ADEQUACY OF STATION ELECTRIC DISTRIBUTION SYSTEM
VOLTAGES, D. C. COOK NUCLEAR PLANT, UNIT NOS. 1
AND 2

Report No. EGG-EA-5339

Technical Evaluation Report

March 1981

Figure 1. D. C. Cook electrical single-line diagram.

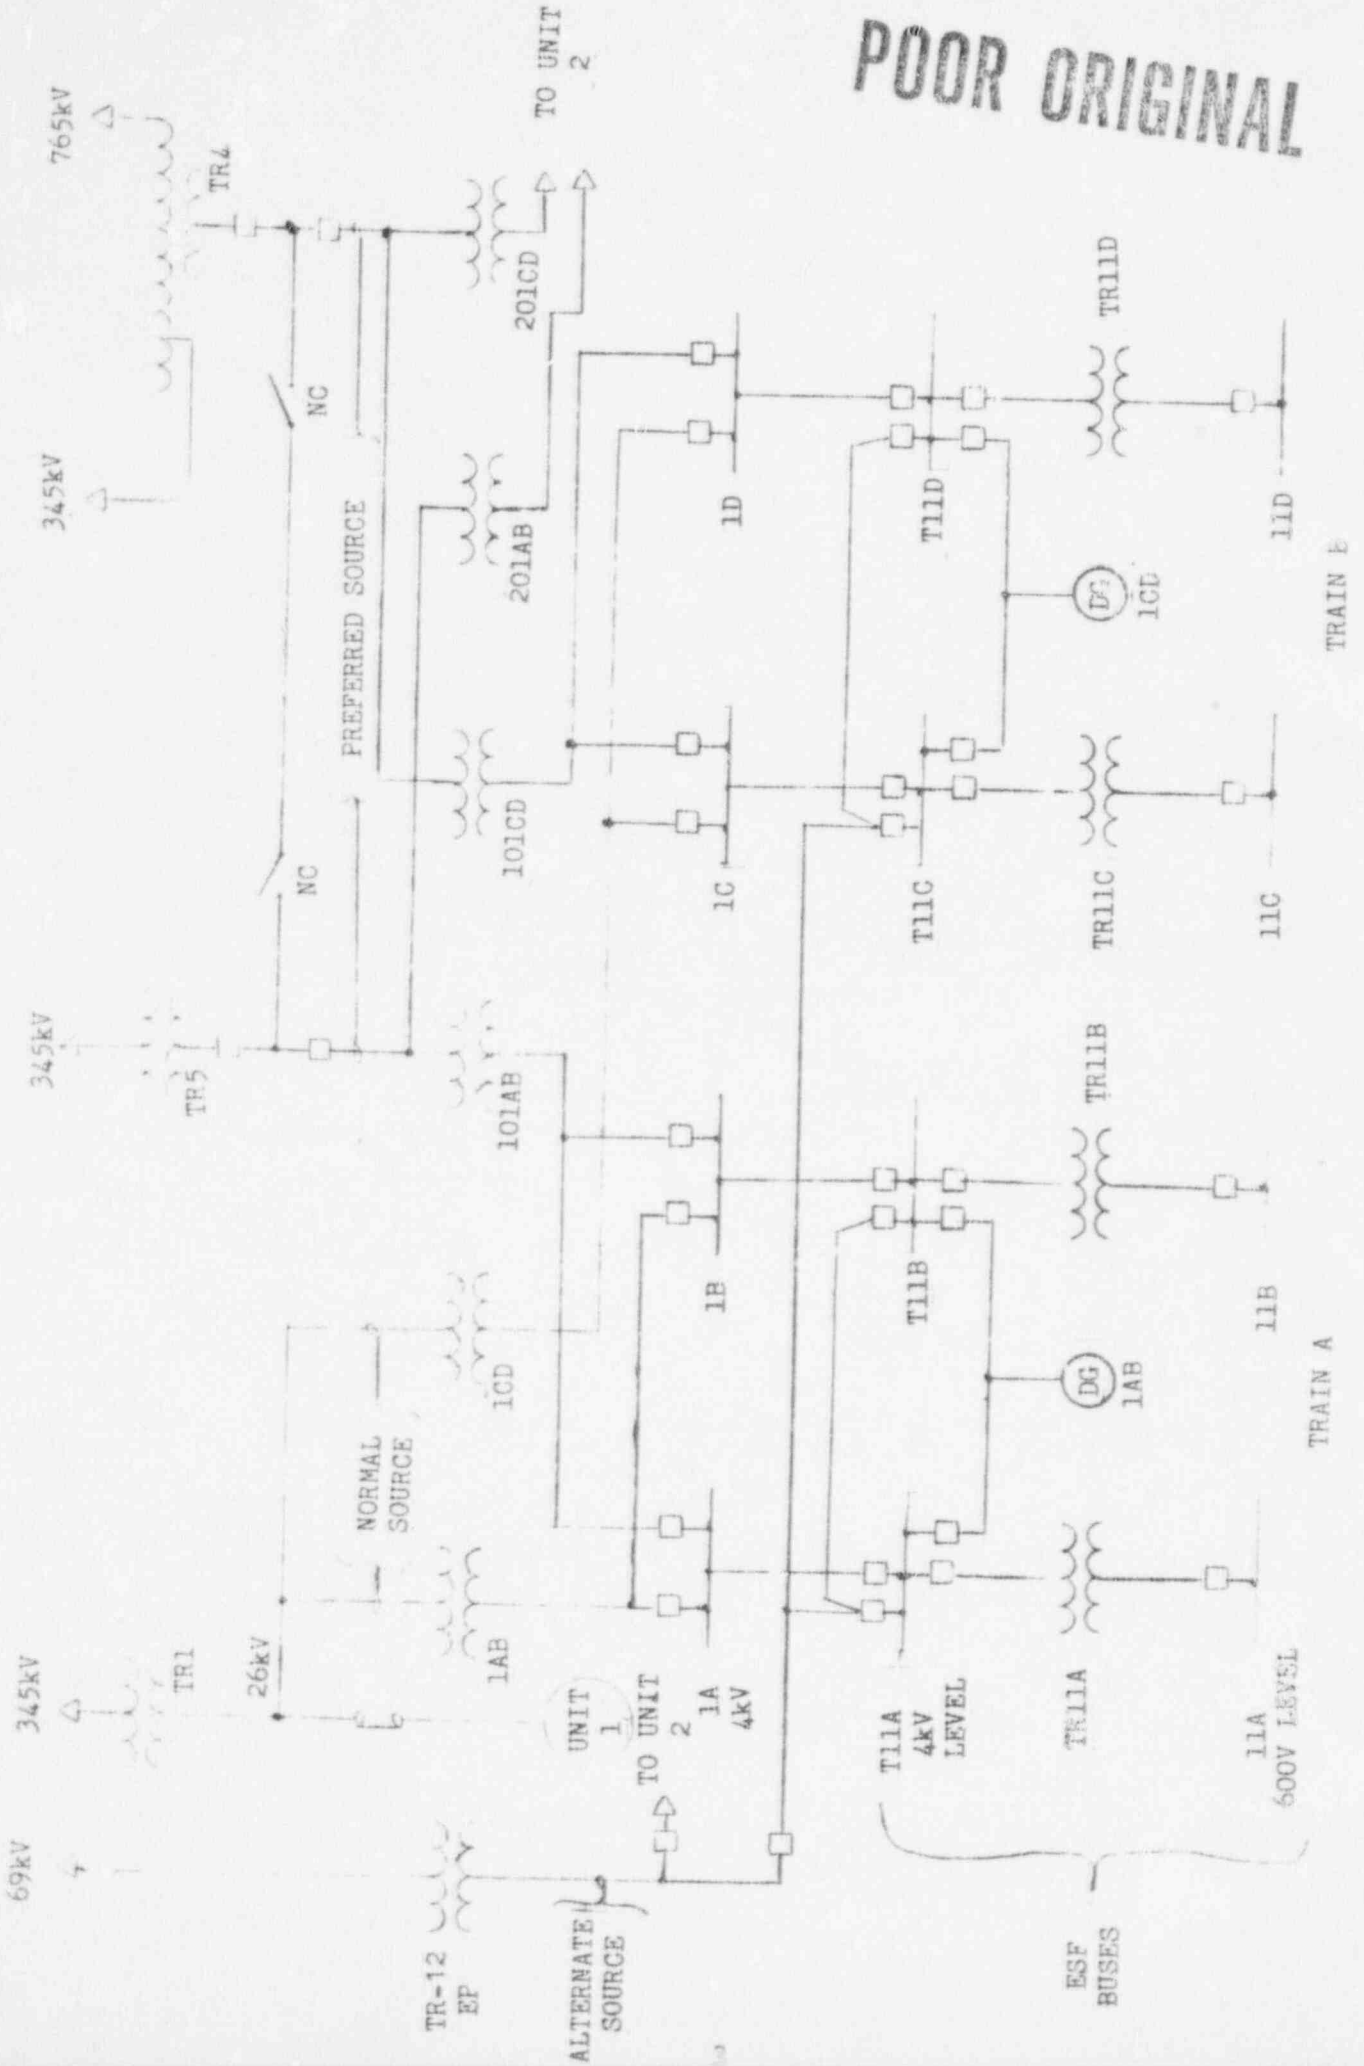
Figure 1 of this report is a simplified sketch of the D. C. Cook Unit 1 single-line diagram.

With the unit producing power, the "normal" auxiliary power to each safety train is supplied from the unit generator via transformers 1-AB and 1-CD (2-AB and 2-CD for Unit 2). A unit trip results in automatic transfer to the "preferred" auxiliary source via TR-4 or TR-5 and TR-101-AB and TR-101-CD (TR-201-AB and TR-201-CD for Unit 2). After the unit generator disconnect links have been removed, the safety buses can be supplied from the "normal" auxiliary power source via TR-1 (TR-2 for Unit 2). TR-12-EP is an "alternate" auxiliary power source to both units.

1. Change the tap setting on TR-12-EP (alternate power source) from the 67kV tap to the 68.8kV tap.
2. Install undervoltage protection on the 4kV buses A and D for Unit 1 and 2 with a voltage setting of 89.9% for two minutes.⁴
3. Modify the existing undervoltage relays at the 4kV buses for a voltage setting of 79.9% for two seconds.
